## RECALL SERVICE BULLETIN

RSB #

505

# MARKER LIGHT AND HEADLIGHT WORK INSTRUCTIONS FOR RECALL 17V 797

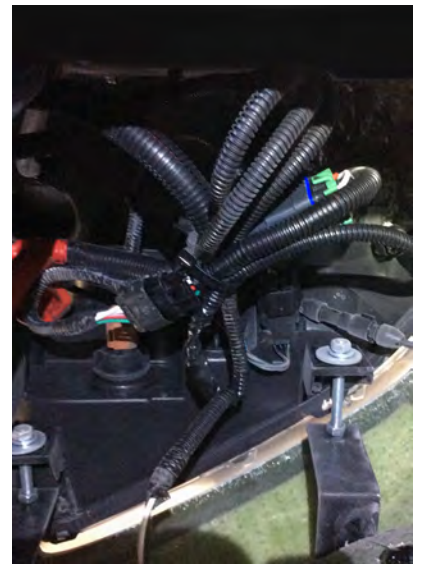
6. Cut the wire feeding into the four lower marker lights.
7. Pull the wire ends out of the loom, and strip the end of each wire.
8. Twist the white wires together, and crimp the yellow connector from the new marker light harness to the white wire.
9. Twist the brown wires together, and crimp the yellow connector from the new marker light harness to the brown wire.
10. Cut off the excess flexible conduit.
11. Heat the butt connectors with a small torch or lighter to create a water tight seal.
